**Correspondence Between
Staff and Applicant
Approval Letter**

Case Reference No: 8-PP-2015 Aire on McDowell

RE: 8-PP-2015
Aire on McDowell

Below are the written responses to the 1st Review Comments dated January 12, 2016.

Attachment: Revised art wall detail

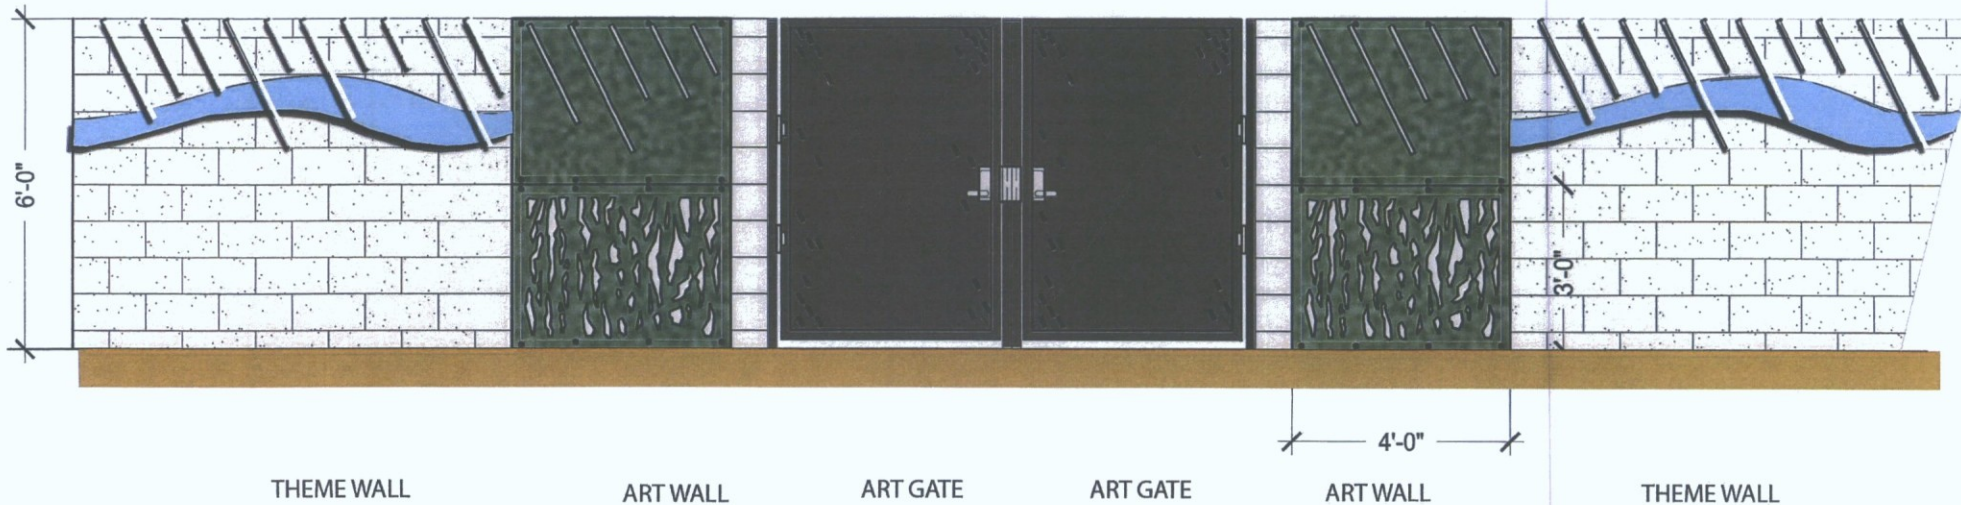
Re: Stipulations 1b and 9 for case 8-PP-2015 (Aire on McDowell)

If there is a motion to approve this case, please include the following amendments in the motion:

Stipulation #1b: The conceptual art wall design provide by the applicant, with a city staff date of ~~3/17/2016~~ 4/21/2016

Stipulation #9: The applicant shall coordinate with the Current Planning Department and submit a separate application for approval of the building elevations. The design of building elevations shall be approved by the Development Review Board prior to ~~City Council approval of the final plat~~ issuance of on-lot building permits.
